**TOWN OF MOUNTAIN VILLAGE
REGULAR DESIGN REVIEW BOARD MEETING AGENDA
THURSDAY SEPTEMBER 5, 2024, 10:00 AM
MOUNTAIN VILLAGE TOWN HALL
455 MOUNTAIN VILLAGE BLVD, MOUNTAIN VILLAGE, COLORADO
TO BE HELD HYBRID THROUGH ZOOM:
<https://us06web.zoom.us/j/82646423126>
Meeting ID: 826 4642 3126**

FROM: Drew Nelson, Senior Planner

TO: Mountain Village Design Review Board
FROM: Drew Nelson, Senior Planner
FOR: Design Review Board Public Hearing; September 5, 2024
DATE: August 27, 2024
RE: Staff Memo – Final Architecture Review (FAR) Lot BC110R, TBD Lawson Overlook

TFPD Compliant

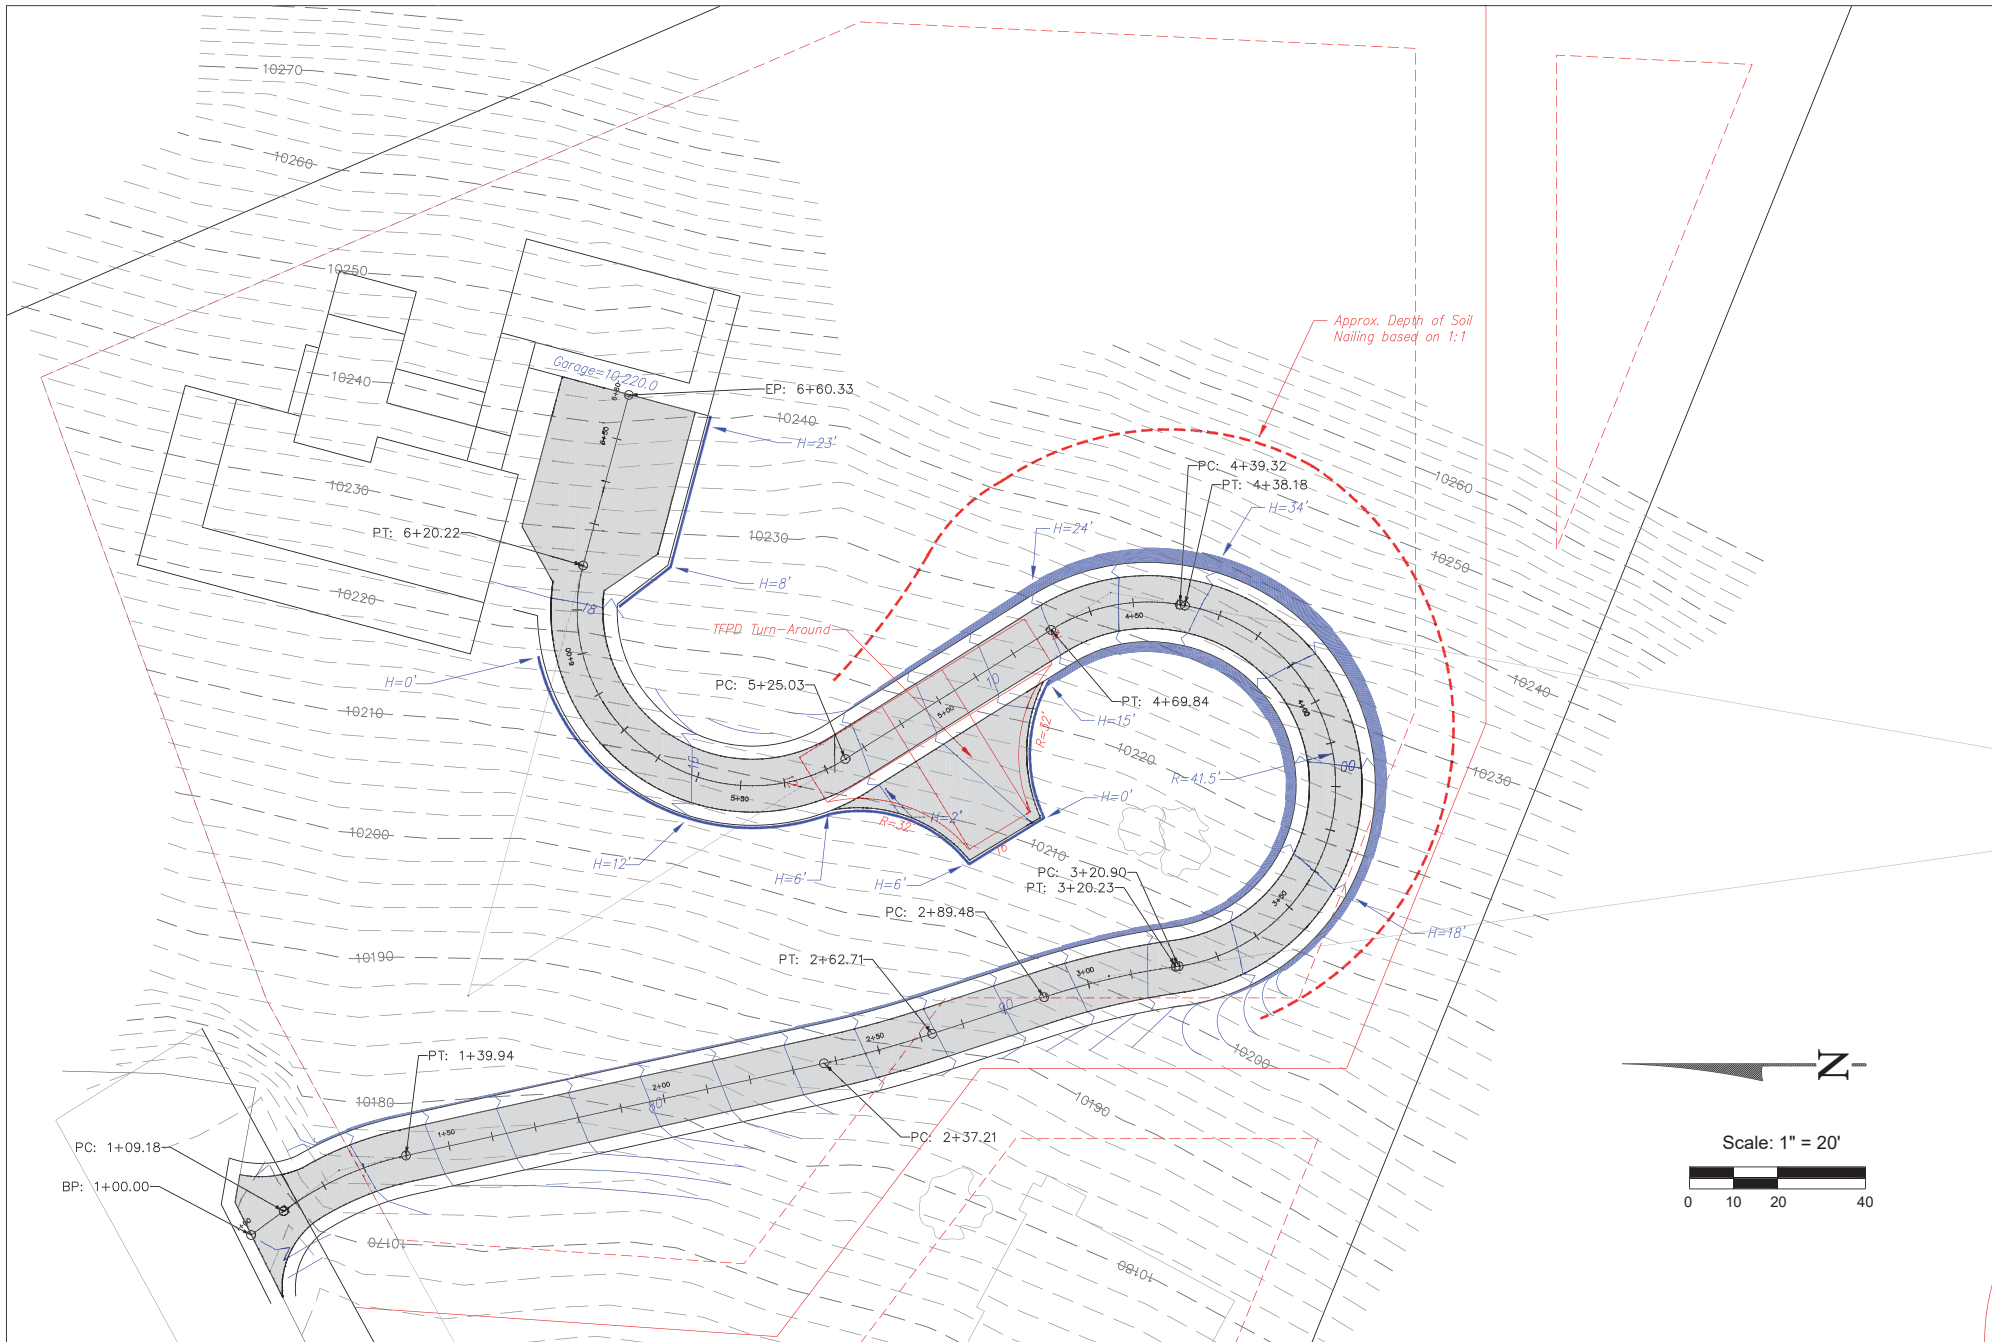
The applicant provided two separate designs in their packet, listed as Scheme A and Scheme B. The applicant's most recent submittal is sheet C2, listed as "TFPD Compliant", which is what Town staff reviewed for this worksession. The most significant change in Scheme B design was the addition of a firetruck turnaround, which is not represented in the most current 3D renderings in this packet (the applicant should provide an updated 3D rendering at the worksession).

Staff Comment: With the driveway length of 560 feet as shown in Scheme B, the CDC requires a driveway width of 16 feet. The applicant has proposed a 12-foot-wide driveway, which does not meet the Town's standards. A wider driveway may necessitate taller retaining walls, which the DRB should discuss. It should be noted that a development site lower down the hill and closer to the access tract would not need such long driveway and could meet the lower driveway width standards. As noted in the project narrative, this design is being proposed specifically to create ski-in/ski-out access to the home.

Staff Comment: The proposal meets some of the provisions of this section of the CDC; however, the two sections of 12% grade are within approximately 110 feet of each other. The TFPD provided the following comments (it should be noted that the design has since been modified):

Figure 2: North Elevation

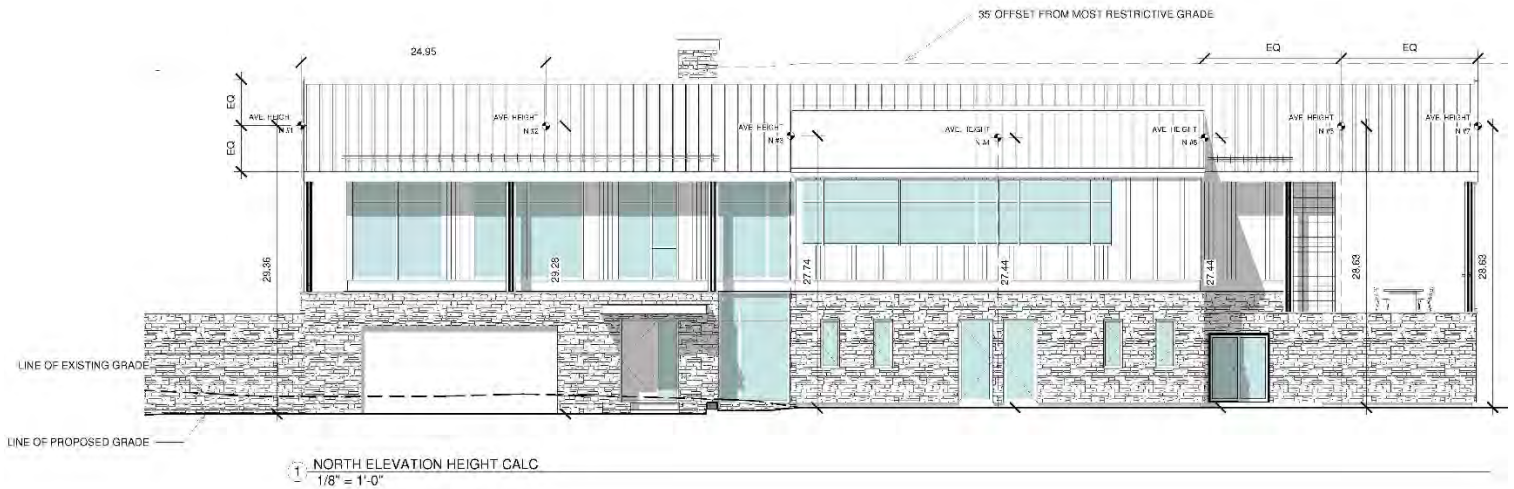
Staff: Staff has determined that the primary roof form for this home is a gable and therefore granted a maximum height of 40 feet. The applicant has demonstrated compliance with max heights on their plan set for both Maximum and Maximum Average heights.

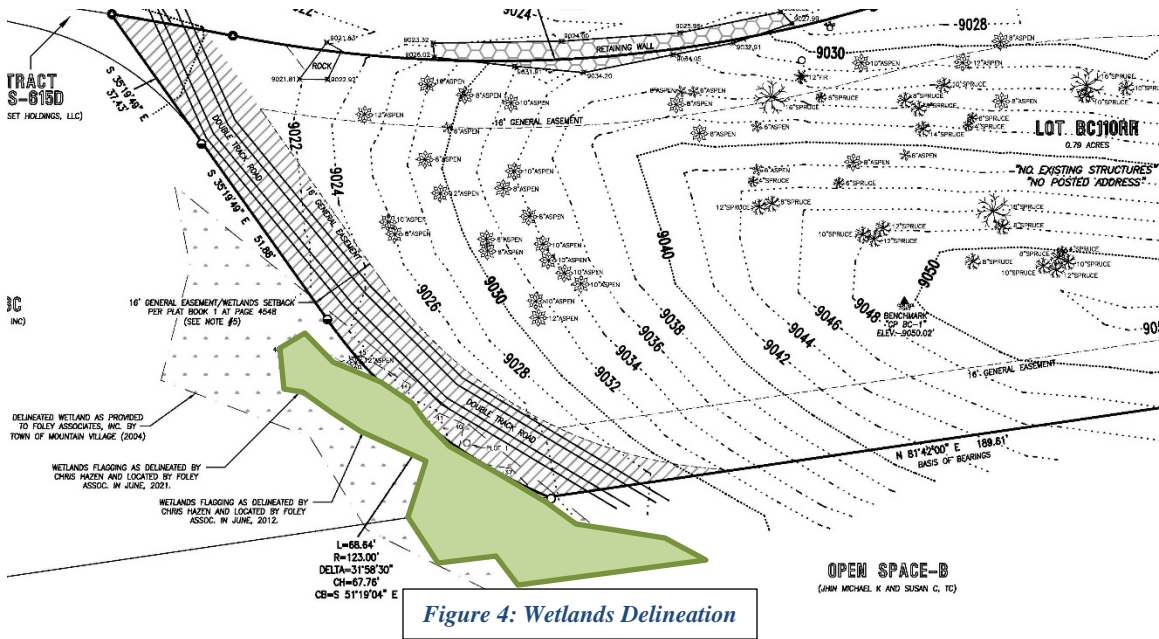
There is a delineated wetland on the southwest corner that just crosses into the GE (see Figure 4), but not into the building area of Lot BC110R. Section 17.6.1.B.2.f requires that all development applications submit a wetlands report performed by a qualified wetlands consultant. It appears that the wetlands were flagged and delineated by a wetlands consultant and surveyed in 2021 that showed a significant reduction in the original wetlands identified per Plat Book 1, Page 4548.

LANDSCAPE PLAN /
FIRE MITIGATION
PLAN

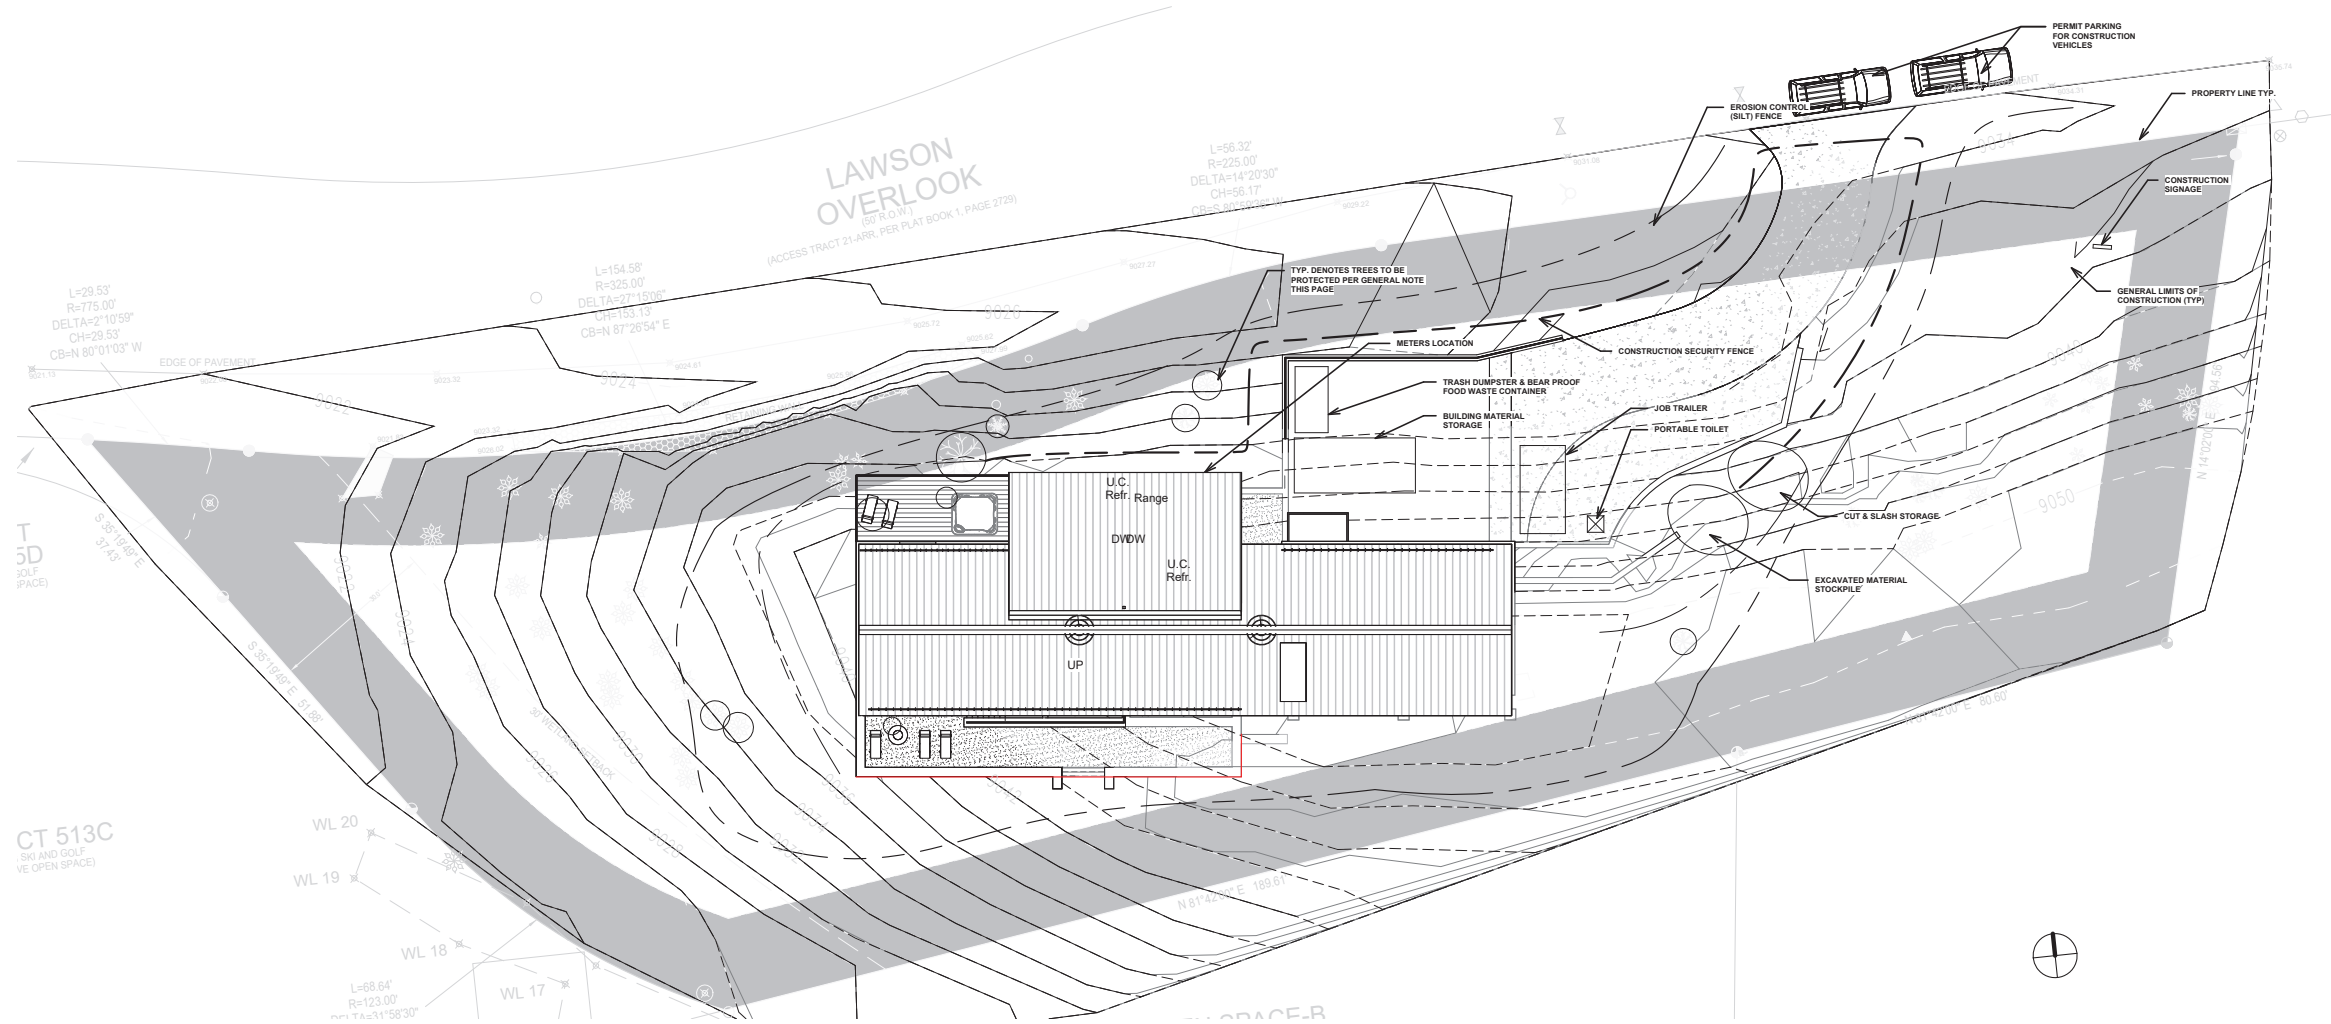
The landscape plan (Sheet A1.2) needs to show the location of where the limits of disturbance fencing will be placed. It needs a distance scale, and it also needs to indicate the location of tree protection fencing for all trees that will be retained within the limits of disturbance fencing. This sheet states that "light grey trees indicated trees to be removed within the limits of construction disturbance, dark grey colored trees to remain in place

③ ADDRESS MONUMENT
1 1/2" = 1'-0"

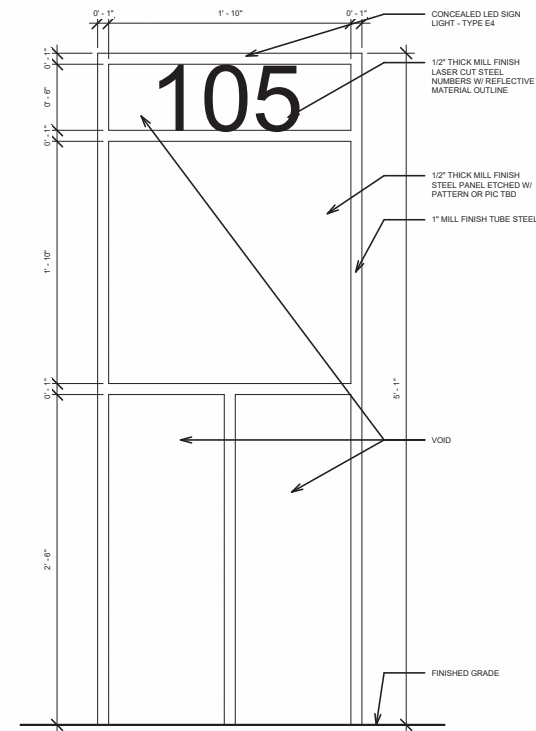
Staff: The address marker is on the east side of the drive will be visible from the street. Materials proposed for the sign are mill finish steel and would be illuminated with an LED strip as noted in the lighting plan.
